NUREG/CR-3300
SAND83-1118
Vol. 1

Review and Evaluation of the Zion Probabilistic Safety Study

Plant Analysis

Figure 8 Hazard Curve Comparison - $M_b = 5.6$ Cutoff

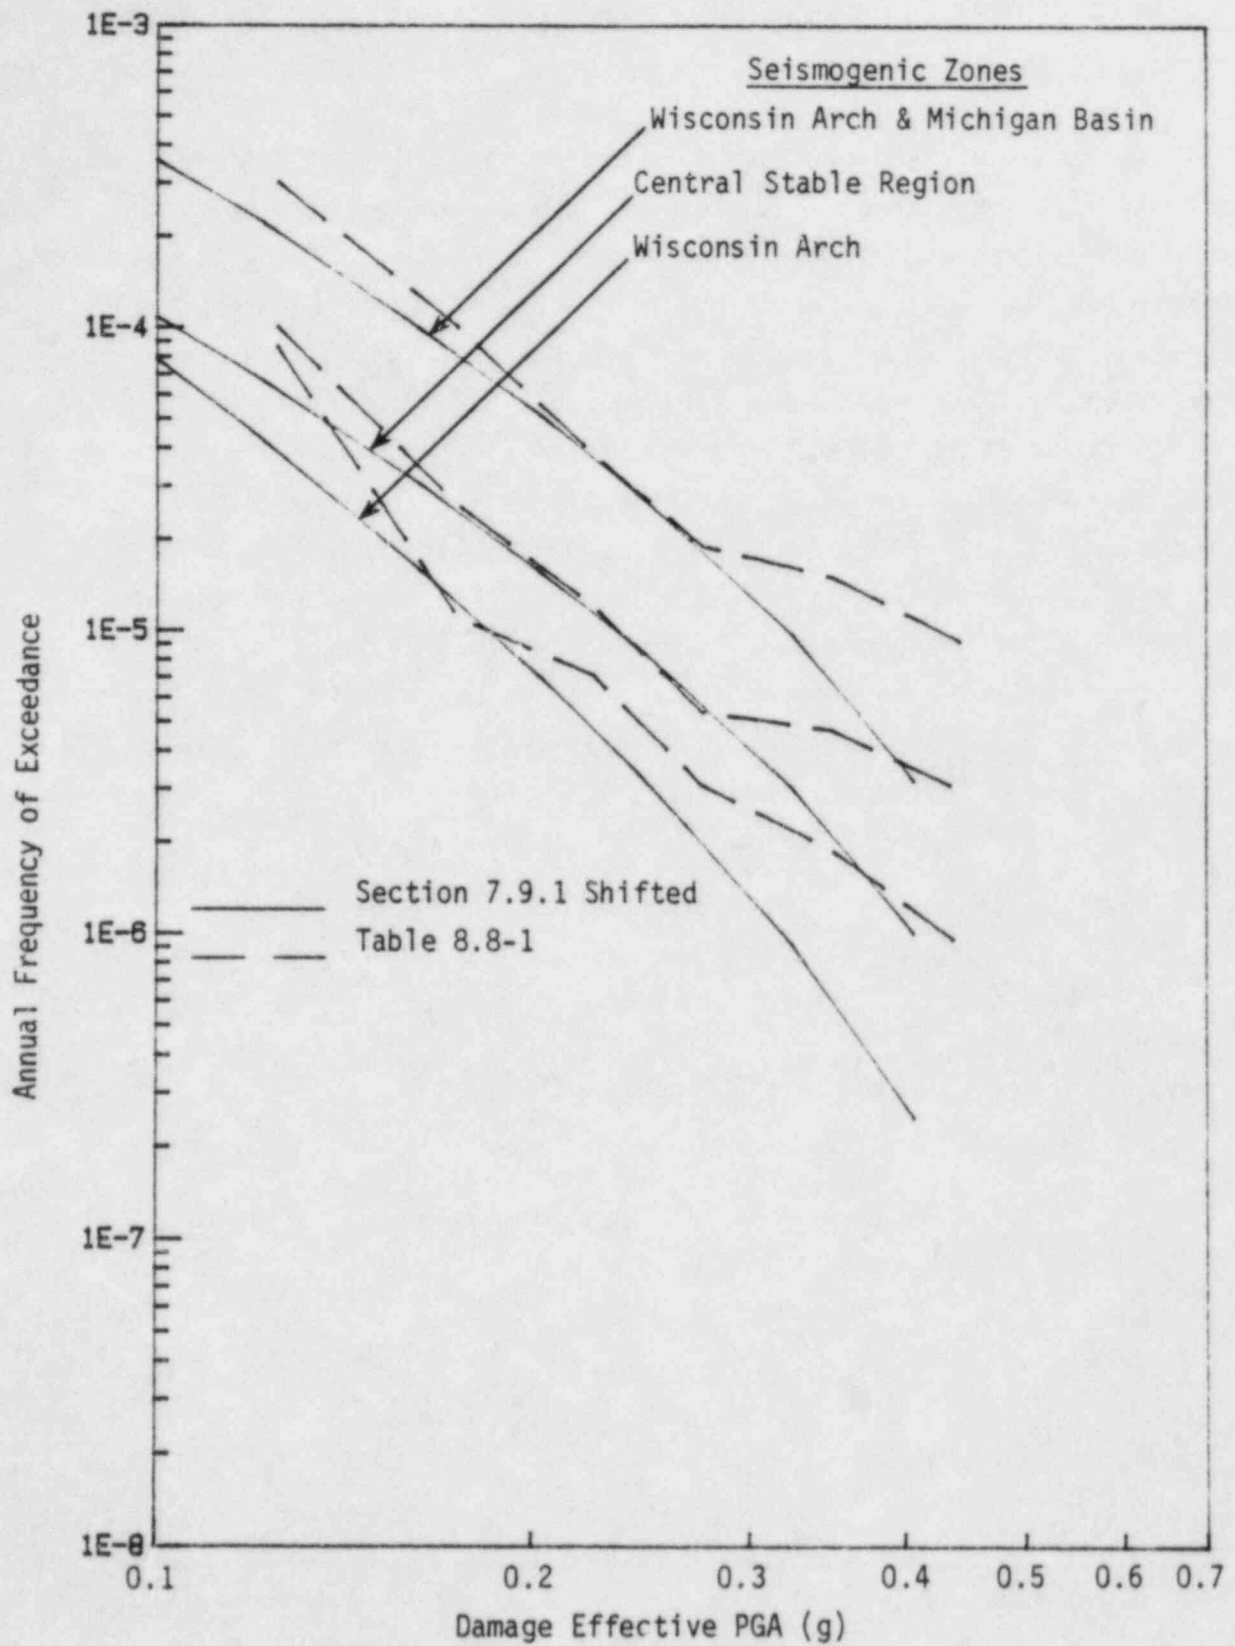
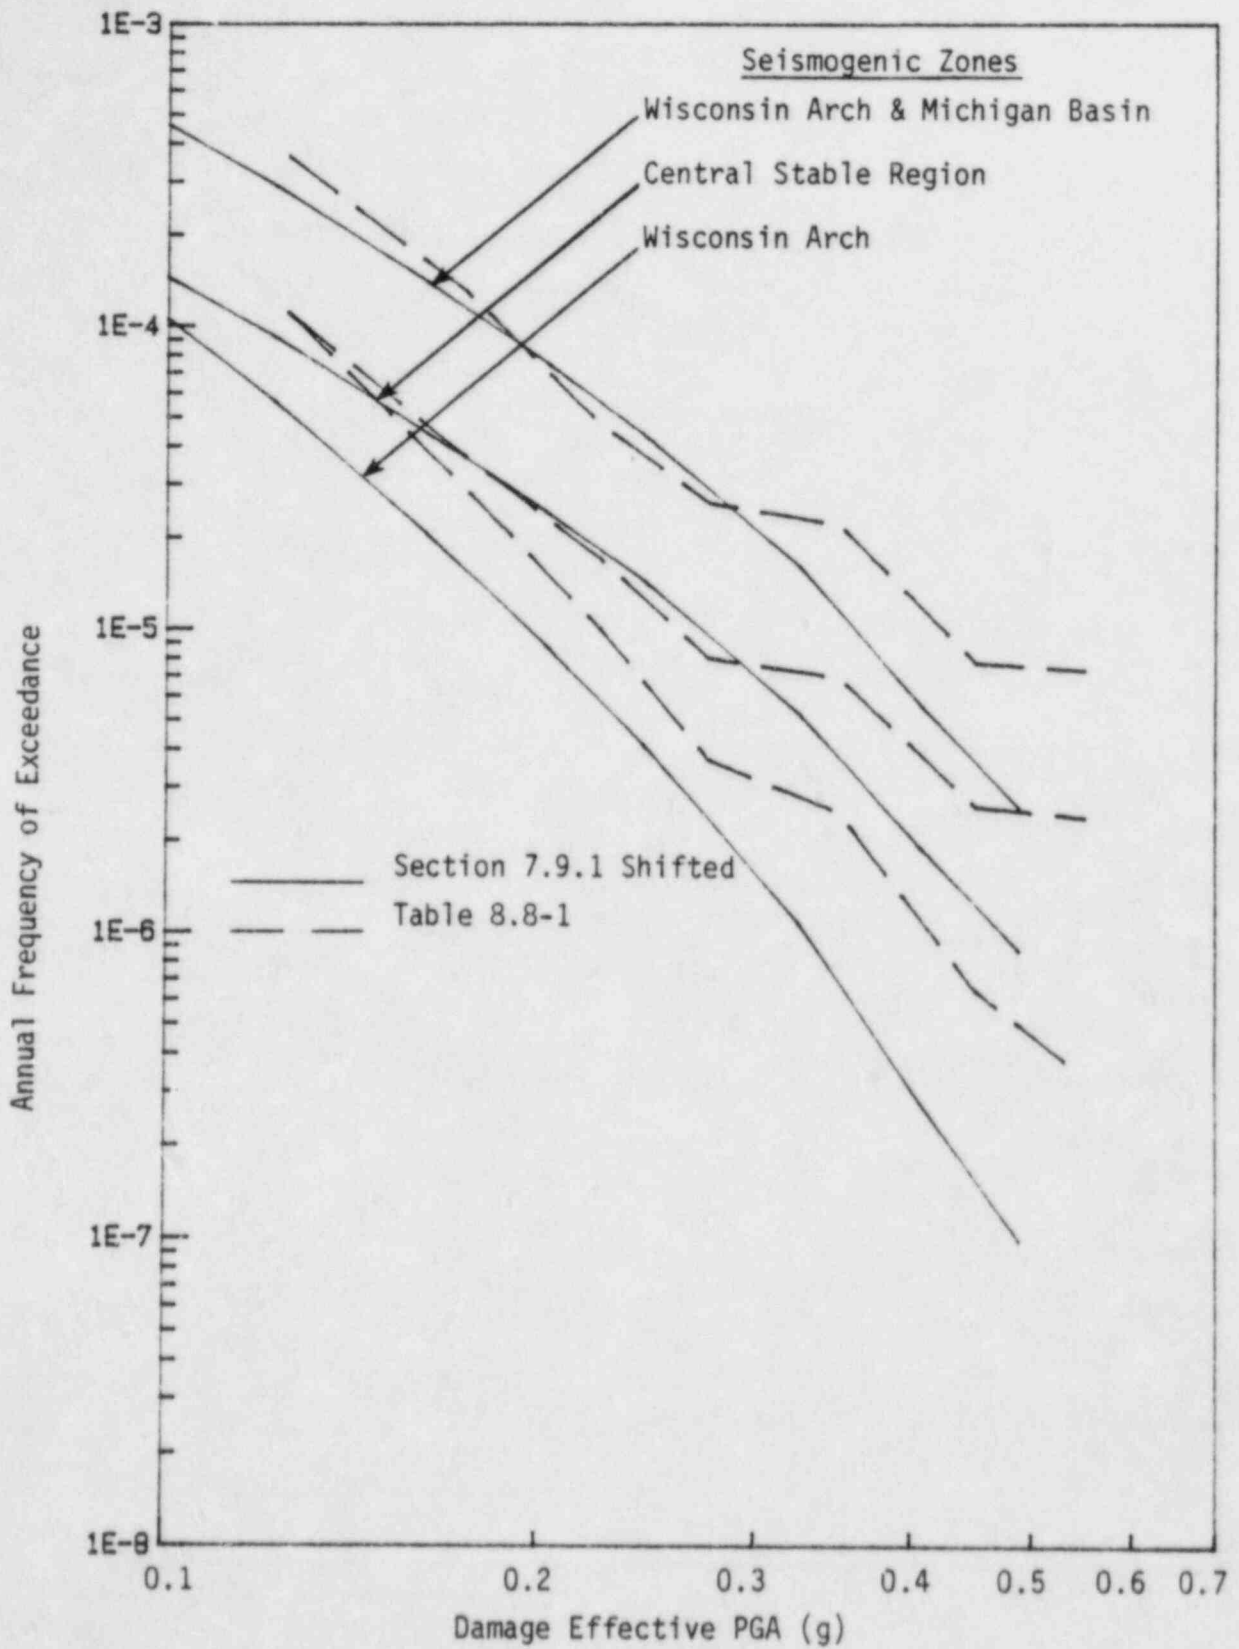
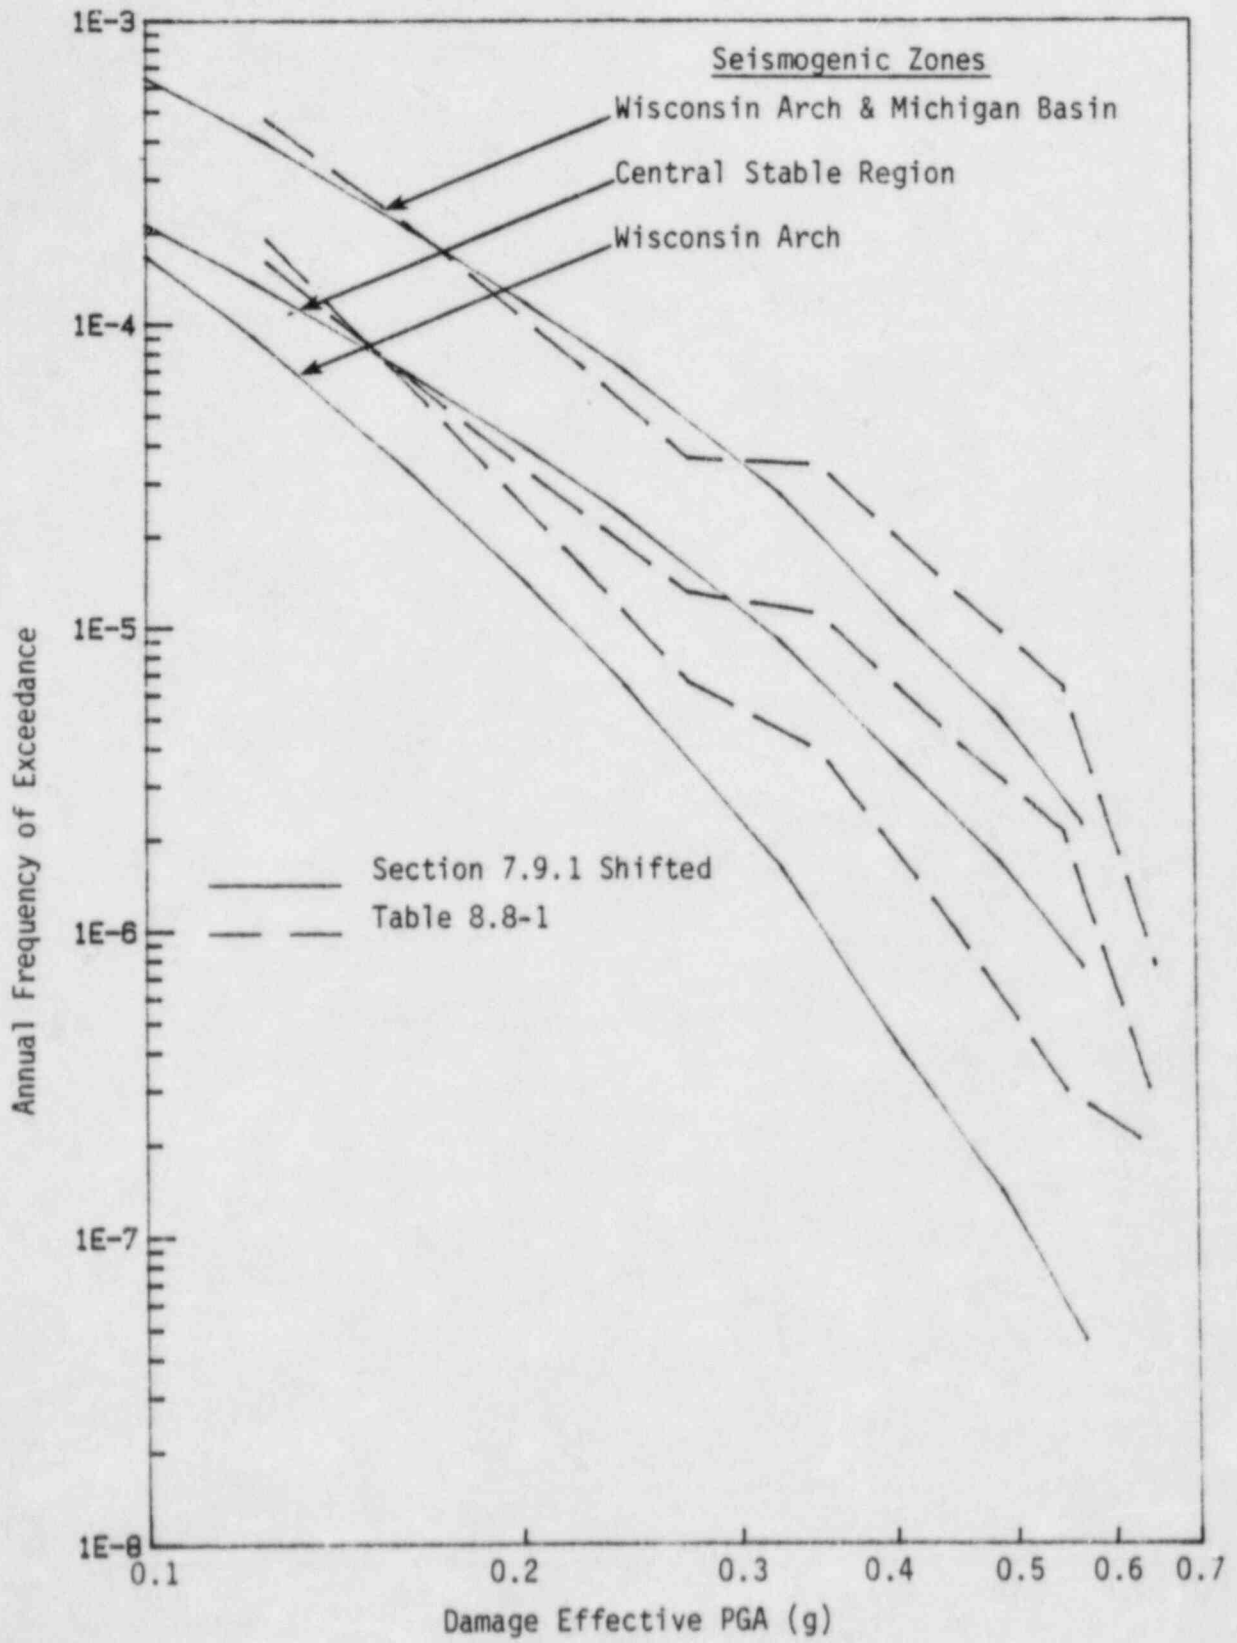
We feel that the frequency of acceleration values at different probability levels given in Table 8.8-1 are at too coarse a spacing to give stable frequency of core melt values in the tails of the probability density function for frequency of core melt (see Figure 7.2-5). Figures 8, 9, and 10 show plots of these values (with obvious corrections to typographical errors in Table 8.8-1) as compared to the data obtained from Section 7.9.1 which have been shifted by a factor of 1.23 and truncated for maximum acceleration values. We expected the corresponding pairs of curves of curves to coincide. The differences are about 30 percent. The effect on the mean frequency of core melt would be small. However, the effect on the tails of the probability density function would be much larger. Based on the Licensee's response given in Appendix A (Question 1), we believe that the hazard values given in Table 8.8-1 are incorrect.

FIGURE 7.9.1-1

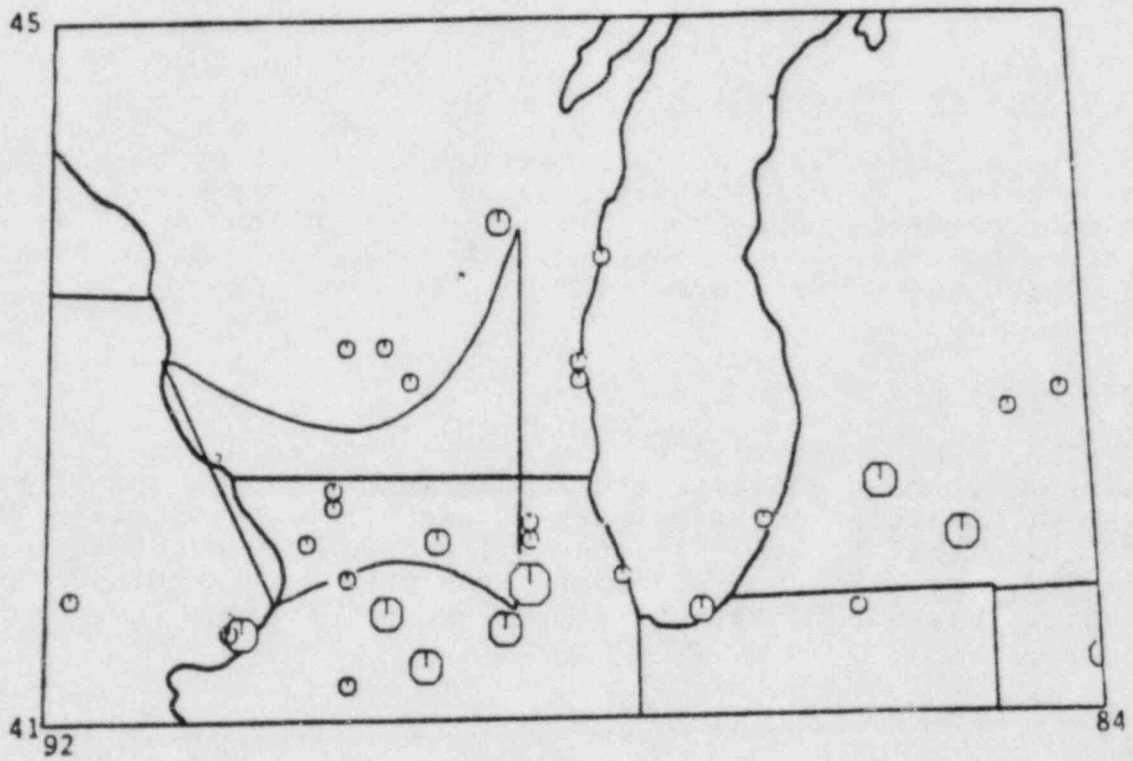
Figure 7.9.1-1 is a plot of the seismicity listed by Nuttli (1979) for the area bounded by the latitudes of 41° and 45°N and the longitudes of 84° and 92°W. The earthquakes in the figure are plotted to scale in accordance to their epicentral intensities. Two earthquakes not shown in the figure, but which appear in Nuttli's (1979) catalog, are the events of February 9, 1899 and May 19, 1906. The first event is listed in Barstow et al. (1981) as not being an earthquake, while the second event was determined to be 800 kegs of blasting powder exploding at Pleasant Praire, Wisconsin.

Another difference between the seismicity plotted in Figure 7.9.1-1 and that listed by Nuttli (1979), is the epicentral location of the May 26, 1909 event. After reviewing the distribution of the earthquake effects, I feel that the epicenter near Aurora, Illinois as suggested by Docekal (1970) is more appropriate than 42.5°N/89.0°W used by Nuttli (1979) and Coffman and von Hake (1973). The results of my review of this event are discussed in detail in Part B of this section.

Illustrated along with the seismicity in Figure 7.9.1-1 is the outline of the proposed Wisconsin Arch seismogenic zone. The proposed zone does a poor job of accounting for the known seismicity in the area and, in my opinion, does not seem to be justified.

Fig. 2 - Upper bound EPA values in the Zion Probabilistic Safety Study (Fig. II.7.1)

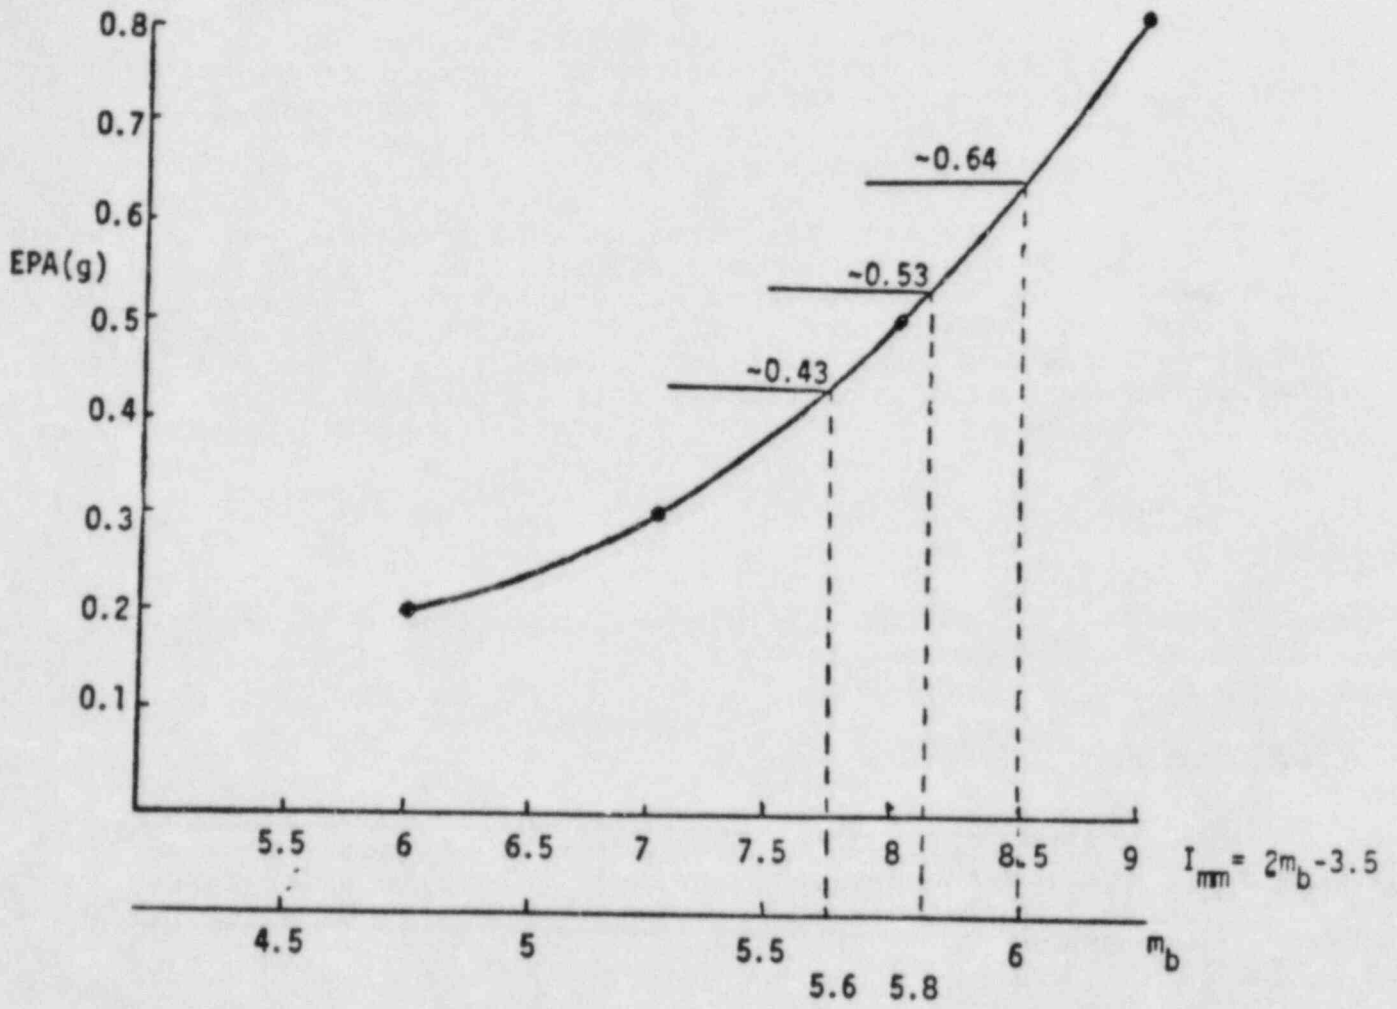
Upper Bound EPA. Treatment of the EPA upper bound is unsatisfactory on several grounds:

1. I cannot follow the argument that imposes limits to the EPA based on limits on I_{mm} . That argument is especially tenuous if EPA is defined as $EPA = A_3F$ (Equation 4 of Section 7.9.3). In this case, the statement at the top of page 12 in Section 7.9.1 does not hold. I also find it objectionable to use damage to masonry construction in order to obtain limits on EPA for non-masonry structures.
2. If an upper bound to EPA exists, such bound should be included through truncation of the attenuation error distribution, not through correction of the final hazard curves.
3. There is no evidence in the report that the curves of Figure II.7.1 have actually been calculated. Rather, I have the impression that the transition between the untruncated curves and the vertical asymptotes have been obtained by direct graphical procedures.

4. I have tried to reconstruct the method used to obtain the upper bounds on EPA in Figure II.7.1. It seems that upper bound intensity values have been found from upper bound magnitudes using the relationship $I_{mm} = 2m_D - 3.5$ and that the associated upper bounds EPA have been calculated by interpolation of the values on page 6 of Section 7.9.3 (see Figure 2 of this report). However, the above relationship between I_{mm} and m_D was obtained by fitting dispersed data and does not apply to upper bounds.
5. Large uncertainty exists on the maximum value of EPA. It would therefore be appropriate to consider alternative values of this parameter through different truncations of the attenuation error distribution.
